International Forest Products Ltd. FLA19220
 Stuart Island Pre-harvest and Post-harvest Visual Assessment Comparison
 RDI Resource Design Inc - September 28, 2013

RDI Resource Design Inc Peer Review September 26, 2011

RDI was requested to provide a peer review of the VIA, including viewpoint selection and weighting, the landform approach, visual force analysis, block design and percent alteration. These were all contained in the Interfor VIA dated September 26, 2011.

MOF1 / CH1 RDI FREP Analysis - 5.48% alteration

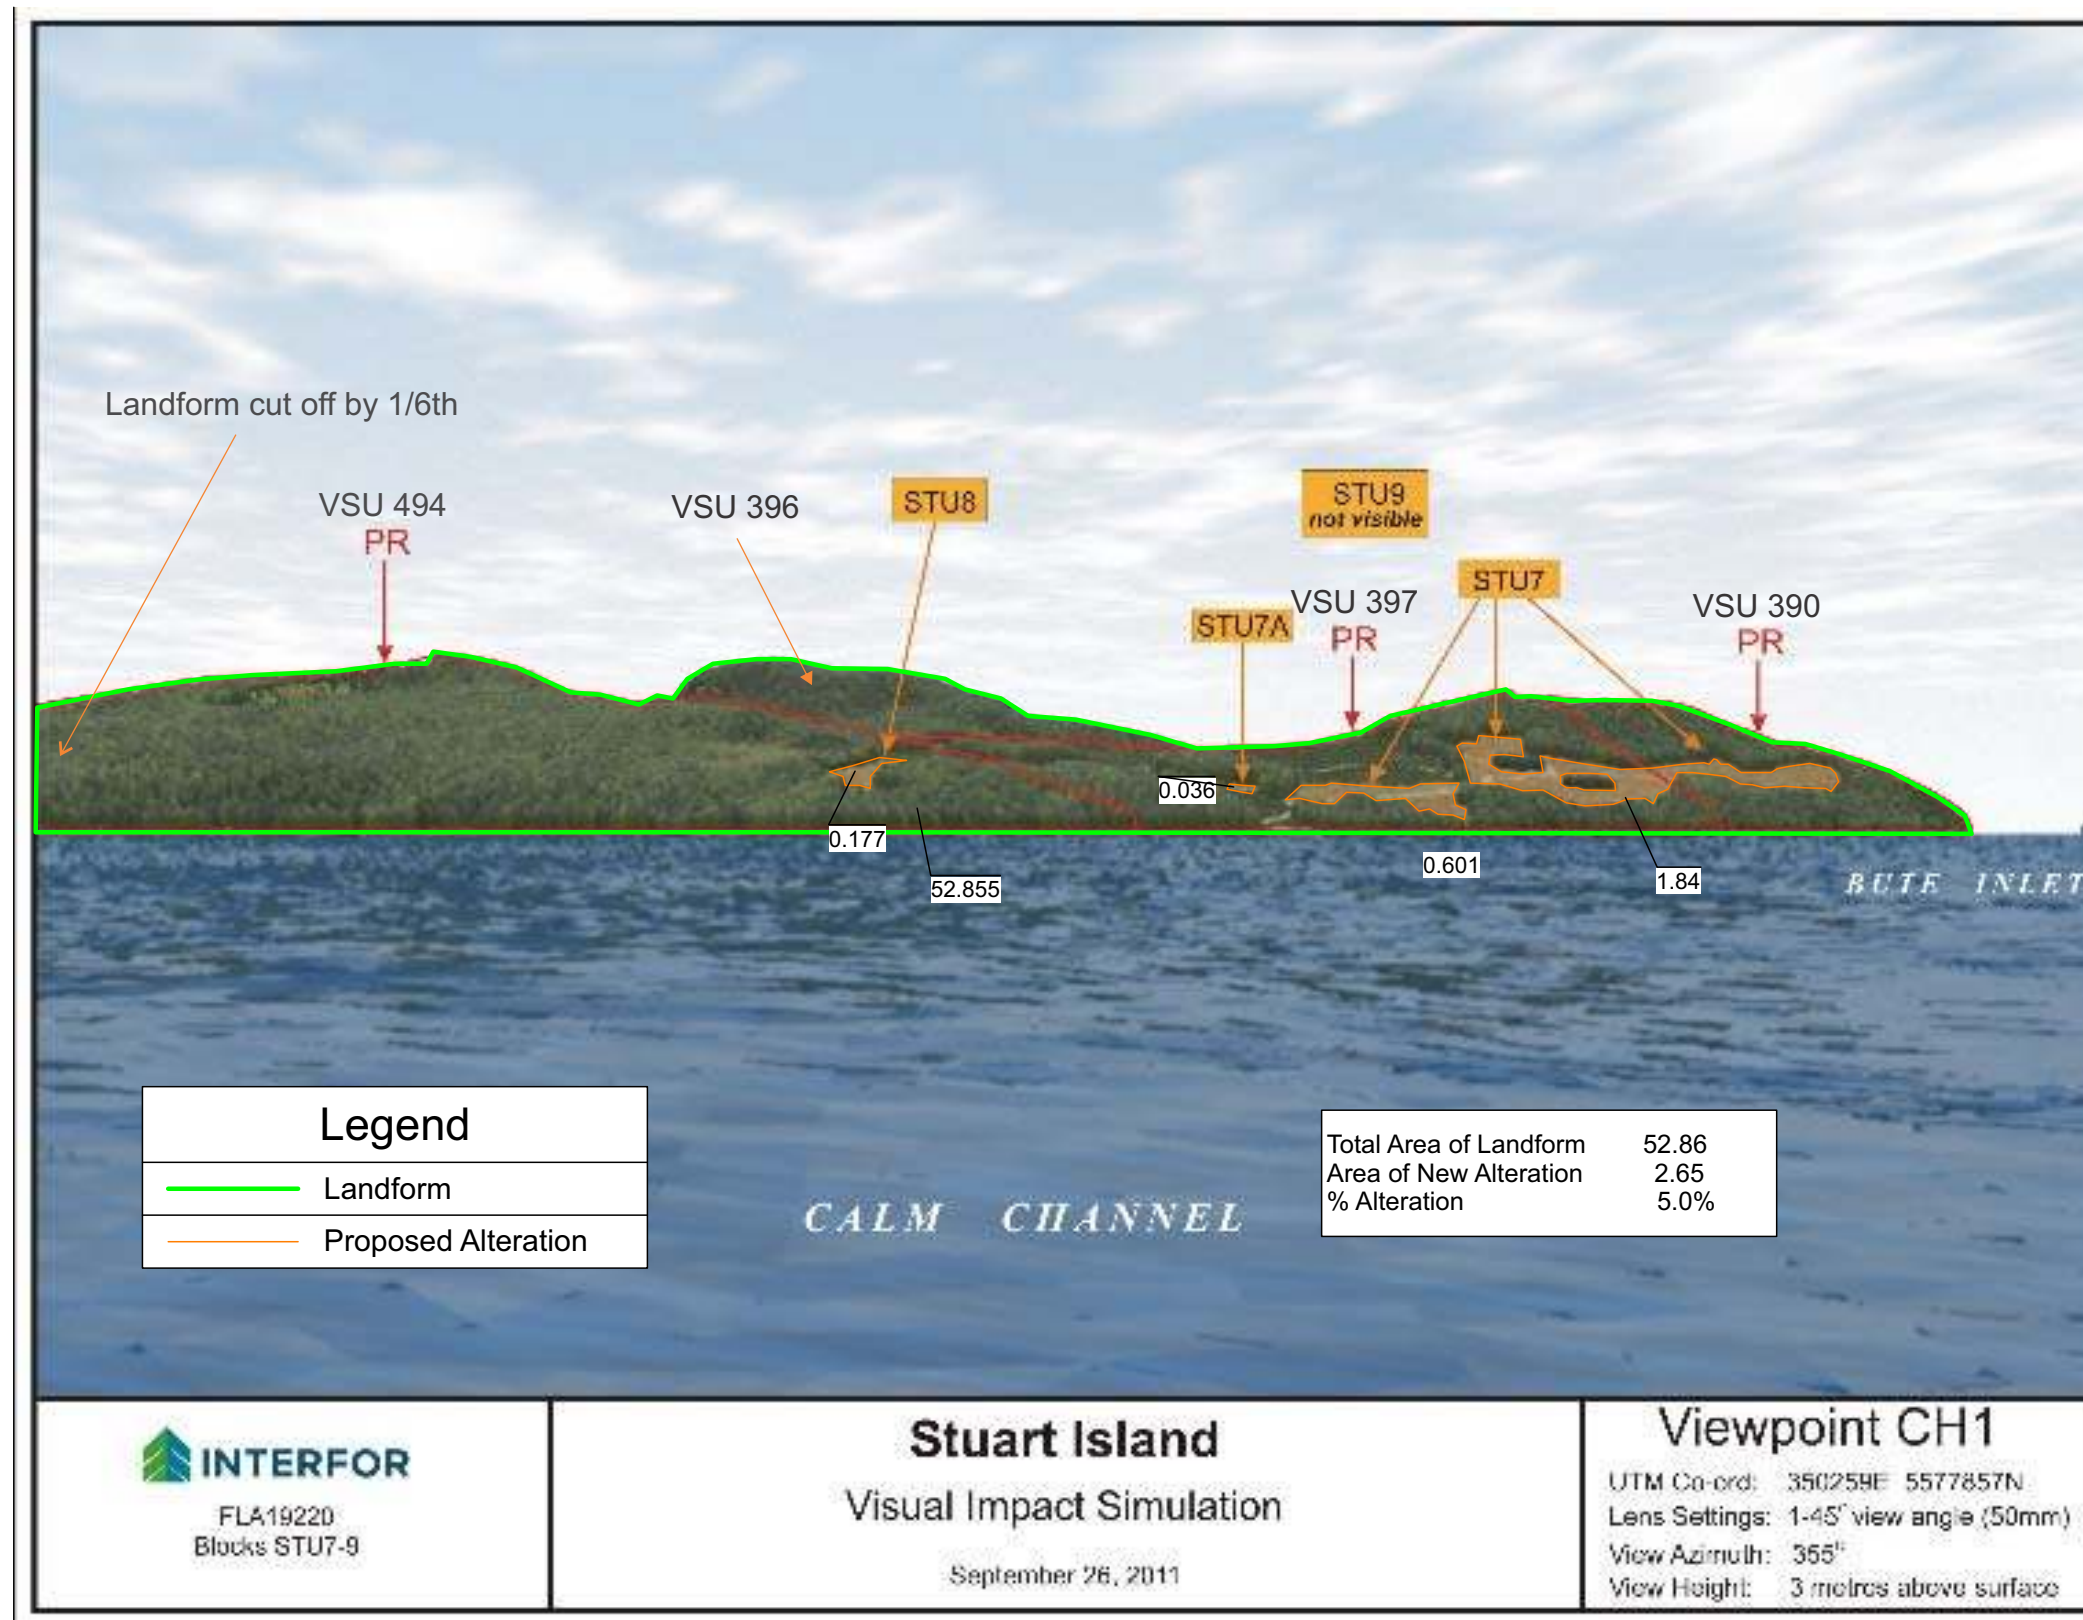
RDI FREP Visual Quality Effectiveness Evaluation Viewpoint MOF1/CH1

2.2.3 Assess Basic VQC (RDI office)				
Basic VQC	PR			
2.2.4 Design Observations (RDI office)				
Design Elements	G (-1)	M (0)	P (+1)	
Response to Visual Force Lines	-1			
Borrows from natural character	-1			
Edge treatments incorporated	-1			
Distance from Viewpoint		0		
Position on Landform**			1	
Total Design	-2

2.3.4 Partial Cut Alterations				
	n/a			
2.3.5 Effectiveness Evaluation Rating				
	PR Met (methods indicate VQO achievement but are close to the high end "maximum percent alteration limit" of 7%.

**Note: Harvesting is in centre vertically, and at one end of landform which warrants a somewhat more positive rating in 2.2.4, and would bring the adjusted % alteration further under 7%. The current definitions in the FREP form do not offer one that is "central vertically on the landform and towards one side".

MOF Calculation from MOF 1 / IFP VP CH1 16.7% alteration and 21.4% alteration with FREP adjustment for STU 7 only
 considered east half of landform only

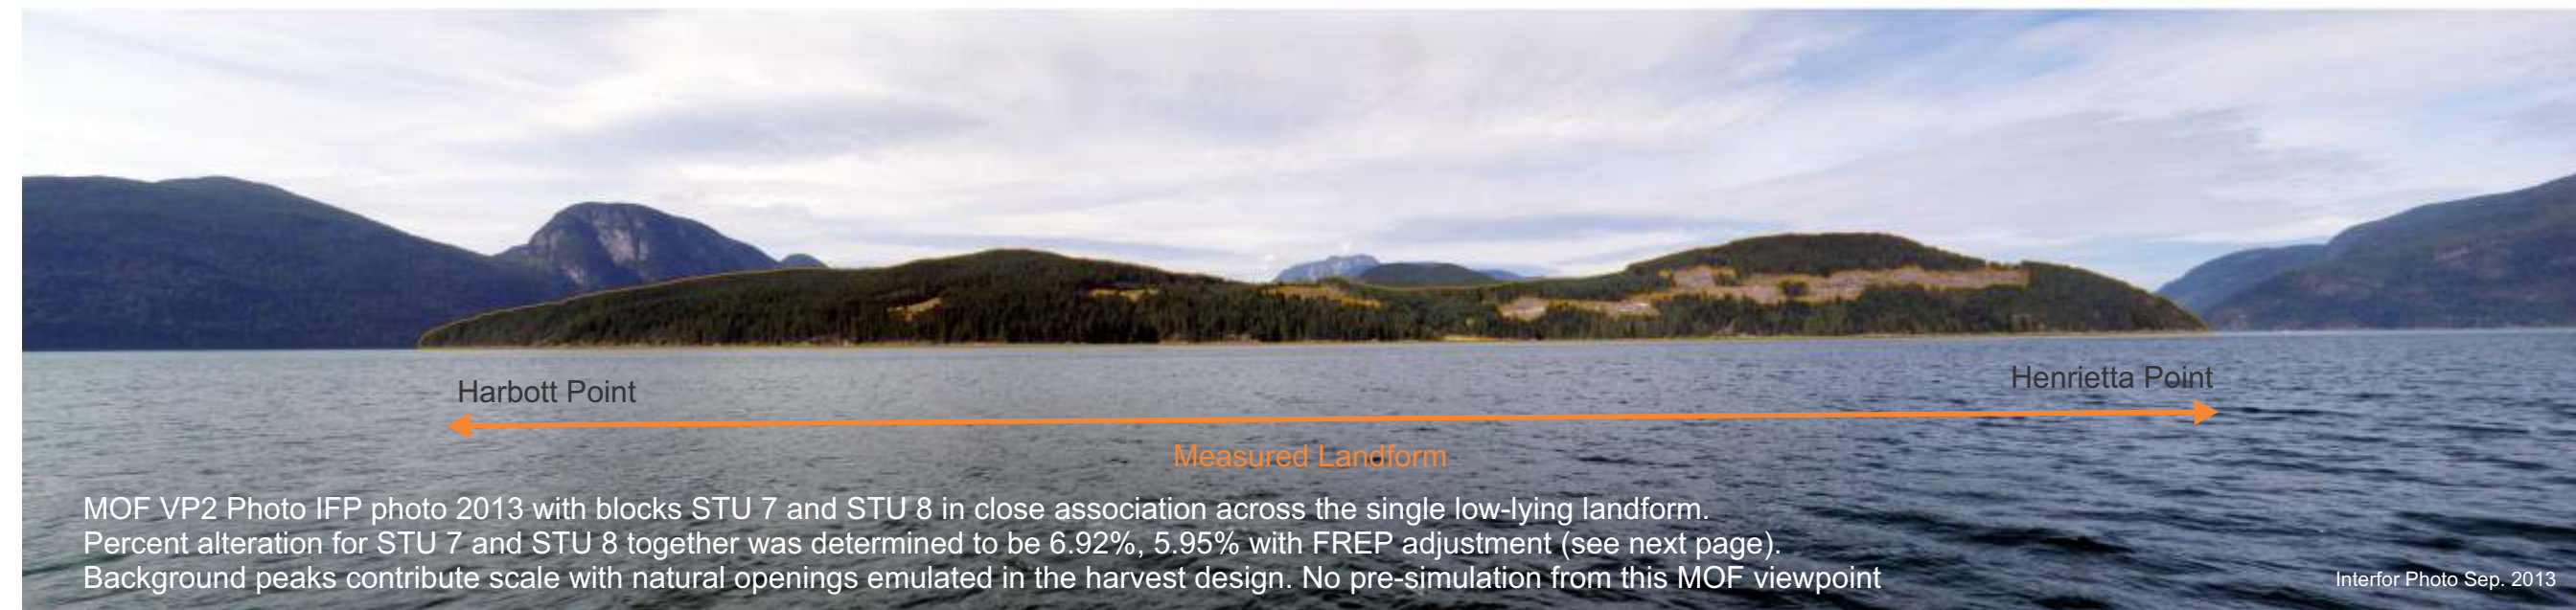
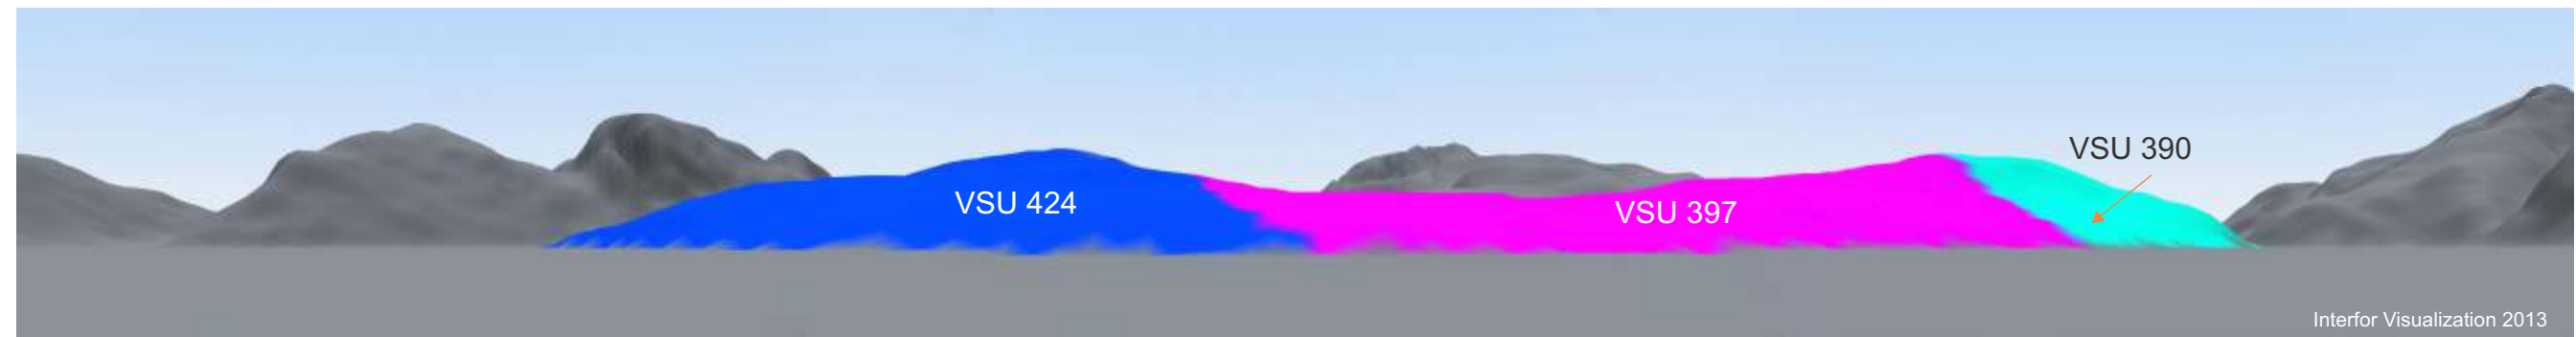
MOF VP1 Photo DSC0173 used in General Inspection Report July 30, 2013.
 The report dealt with the landform as divided east and west along the ridge between the 2 low-lying hills.
 Blocks STU 7 and STU 8 separately though visibly associated.
 Percent alteration for STU 7 was determined to be 16.7% of the east part of the landform (VQEE changed it to 21.4%).

MOF2 RDI FREP Analysis - 5.95% alteration

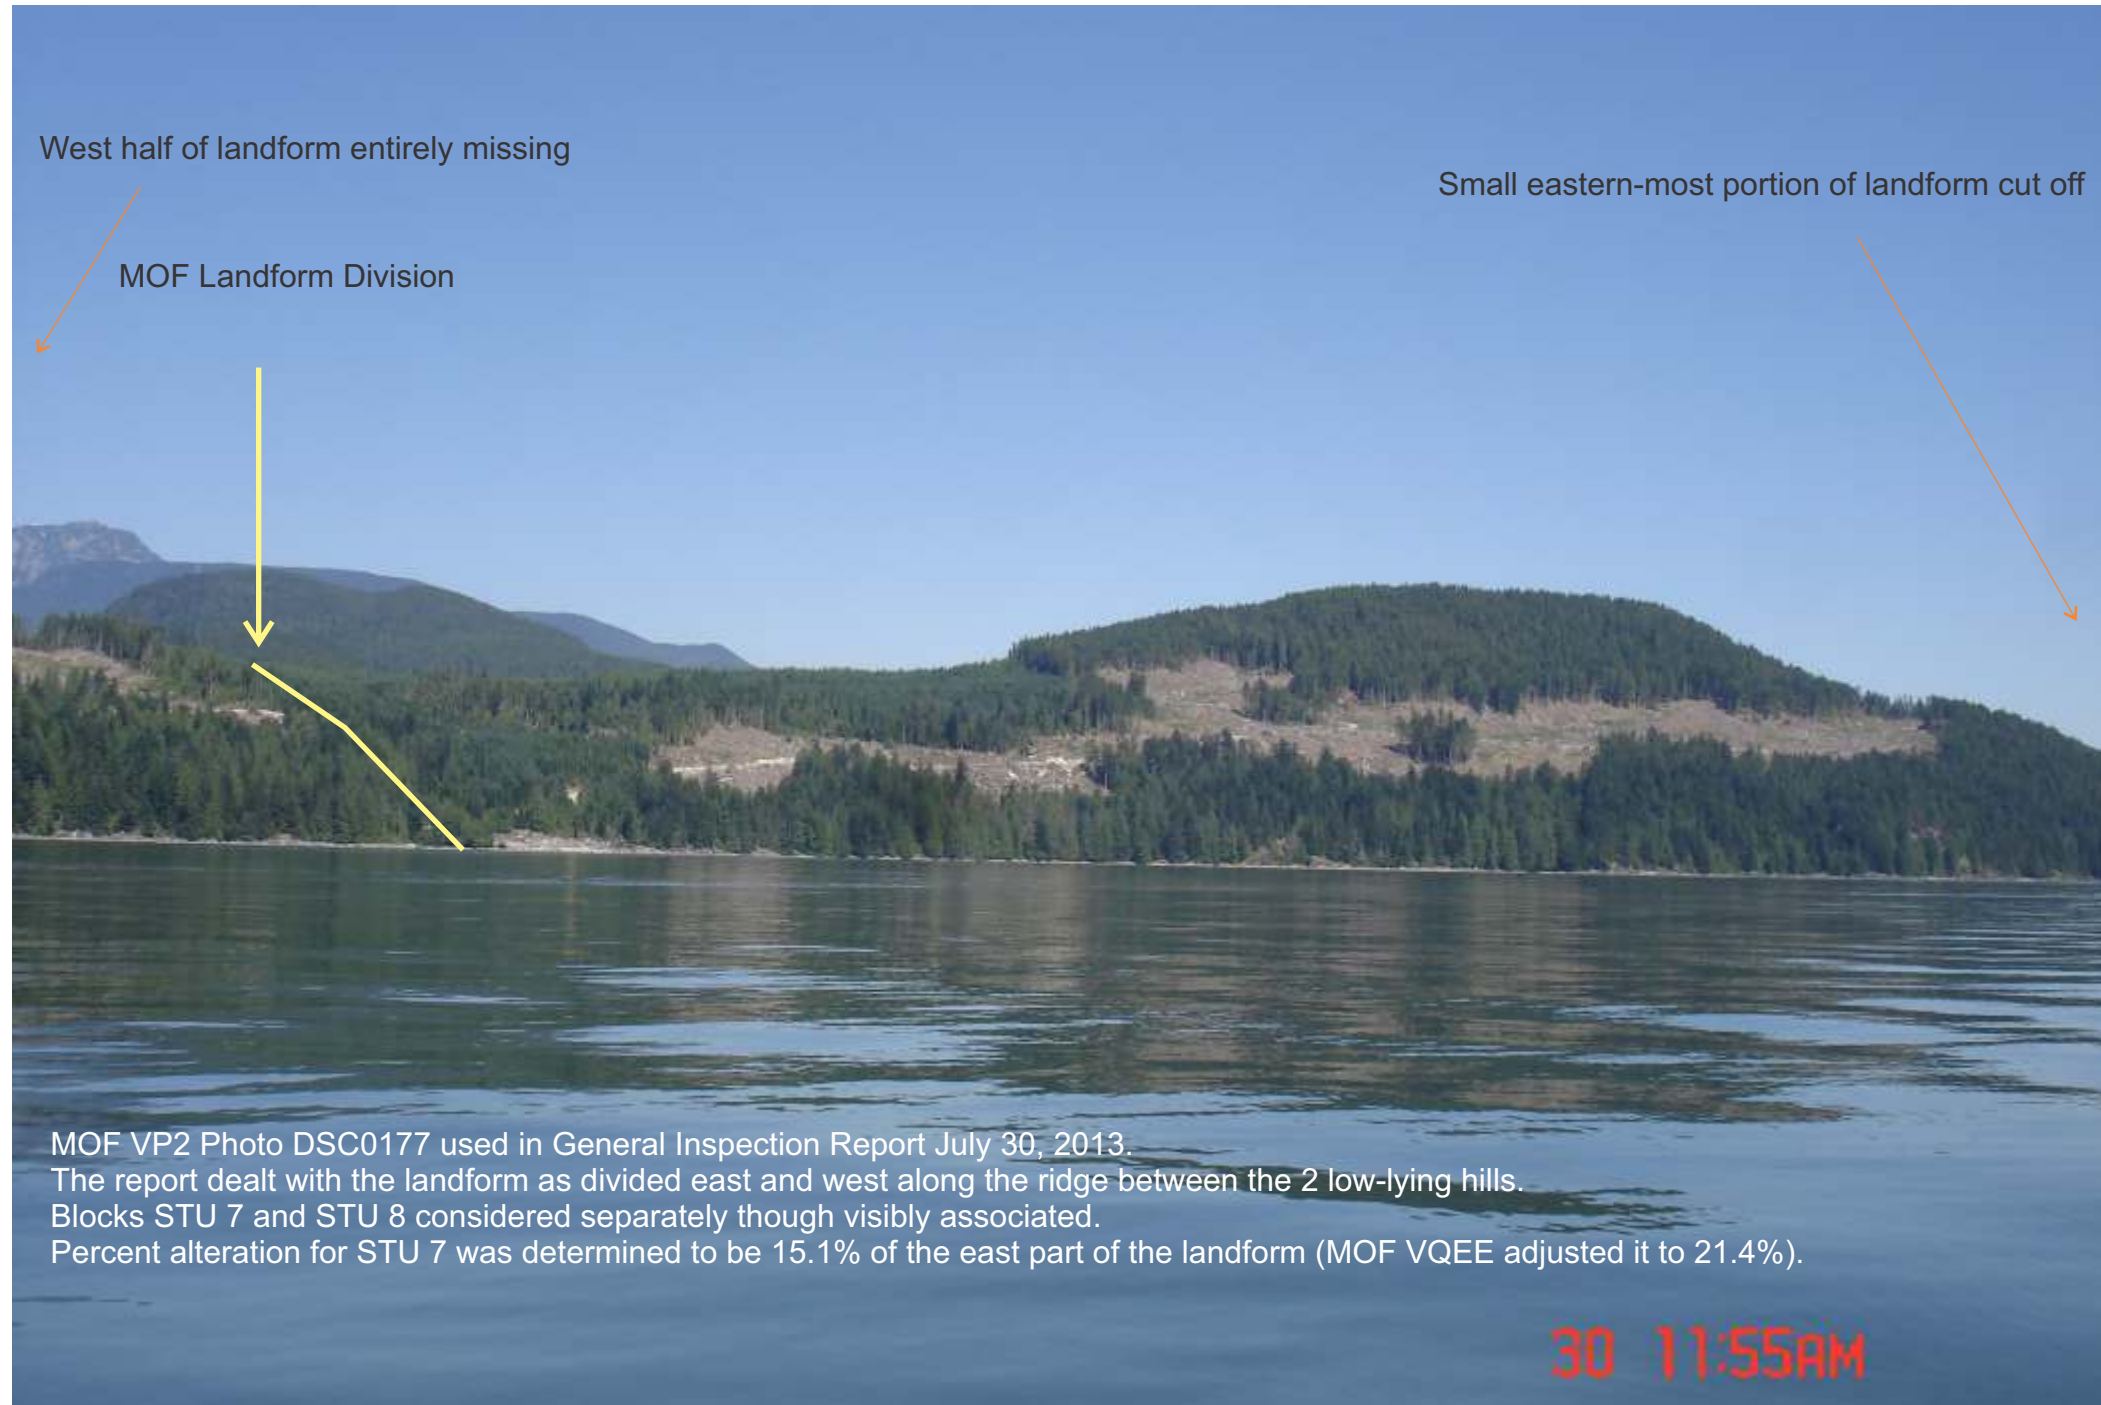
RDI FREP Visual Quality Effectiveness Evaluation Viewpoint MOF2

2.2.3 Assess Basic VQC (RDI office)			
Basic VQC	PR		
2.2.4 Design Observations (RDI office)			
Design Elements	G (-1)	M (0)	P (+1)
Response to Visual Force Lines	-1		
Borrows from natural character	-1		
Edge treatments incorporated	-1		
Distance from Viewpoint		0	
Position on Landform**			1
Total Design	-2

2.3.4 Partial Cut Alterations			
	n/a		
2.3.5 Effectiveness Evaluation Rating			
	PR Met (methods indicate VQO achievement but are close to the high end "maximum percent alteration limit" of 7%.

**Note: Harvesting is in centre vertically, and at one end of landform which warrants a somewhat more positive rating in 2.2.4, and would bring the adjusted % alteration further under 7%. The current definitions in the FREP form do not offer one that is "central vertically on the landform and towards one side".

MOF calculation from MOF VP2 15.1% and FREP 21.4% alteration for STU 7 only
Considered east half of landform only

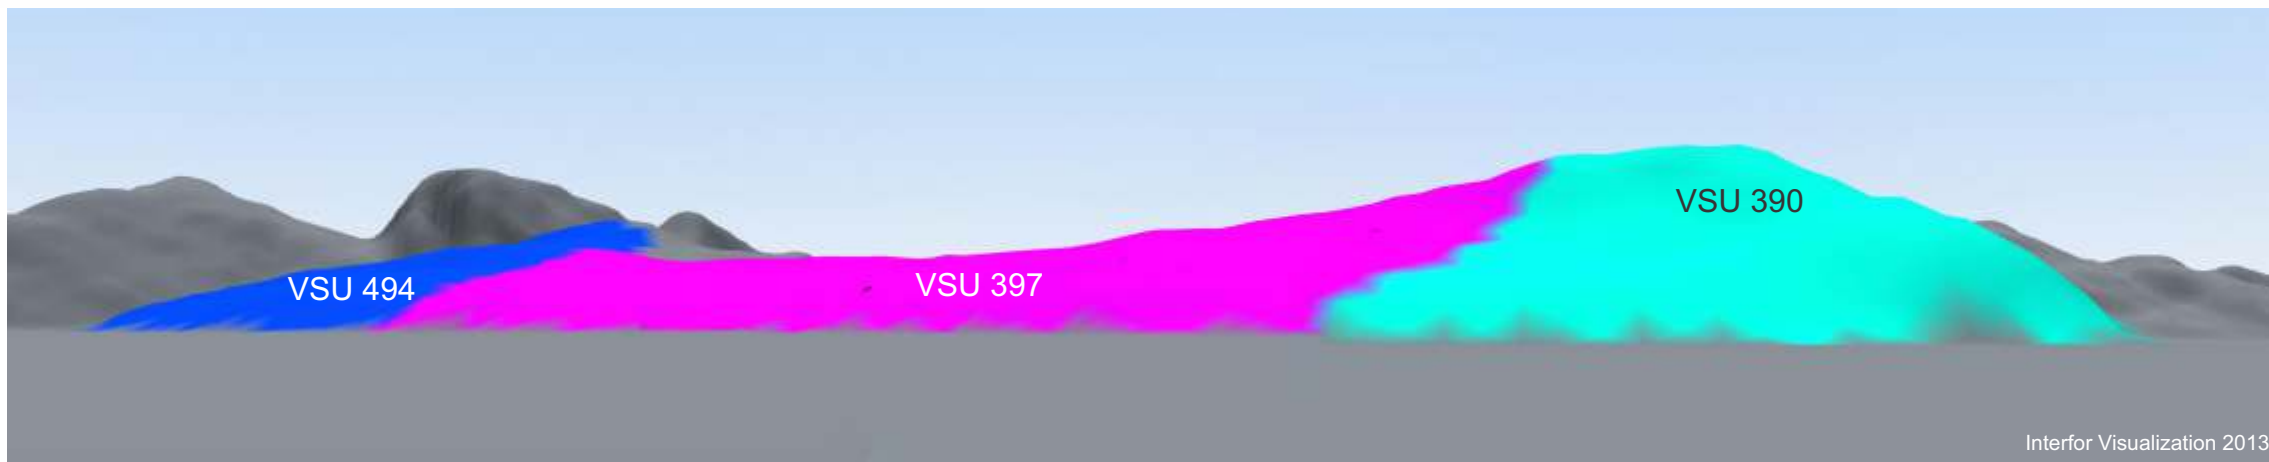
MOF VP2 Photo DSC0177 used in General Inspection Report July 30, 2013.
The report dealt with the landform as divided east and west along the ridge between the 2 low-lying hills.
Blocks STU 7 and STU 8 considered separately though visibly associated.
Percent alteration for STU 7 was determined to be 15.1% of the east part of the landform (MOF VQEE adjusted it to 21.4%).
